# Access Compliance Report

## Public Rights-of-Way

### (Pedestrian Signals)

| ADA ID: FC6CD10F0271                    | Signal Type: Two Push Buttons-Non APS | Overall Compliance: No                  | Severity Score: BTN 1:N/A BTN 2: N/A No BTN: N/A |

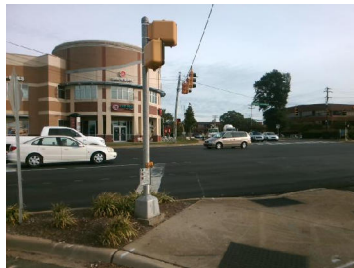
PROW/ADA: R209.1, TMUTCD 4e.08, R404.3, R404.2, R406.2

| Compliance | Description                             | Data    | Compliance | Description                            | Data |
|------------|-----------------------------------------|---------|------------|----------------------------------------|------|
| No         | B 1 Parallel To XWalk?                  | No      | Yes        | B 2 Parallel To XWalk?                 | Yes  |
| No         | B 1 PAR to Button?                      | No      | No         | B 2 PAR to Button?                     | No   |
| No         | B 1 PAR to XWalk?                       | No      | No         | B 2 PAR to XWalk?                      | No   |
| No         | B 1 FWD Approach Reach (in)             | 9.0     | No         | B 2 FWD Approach Reach (in)            | 9.0  |
| No         | B 1 Clear Floor Space XSlope (%)        | 3.9     | No         | B 2 Clear Floor Space XSlope (%)       | 7.6  |

| No  | B 1 DistanceTo Curb (in)  | 204.0         | No  | B 2 DistanceTo Curb (in)  | 96.0          |

Possible Solutions: Replace Signal Push Button With APS Button on New Post. Remove & Relocate Sign.
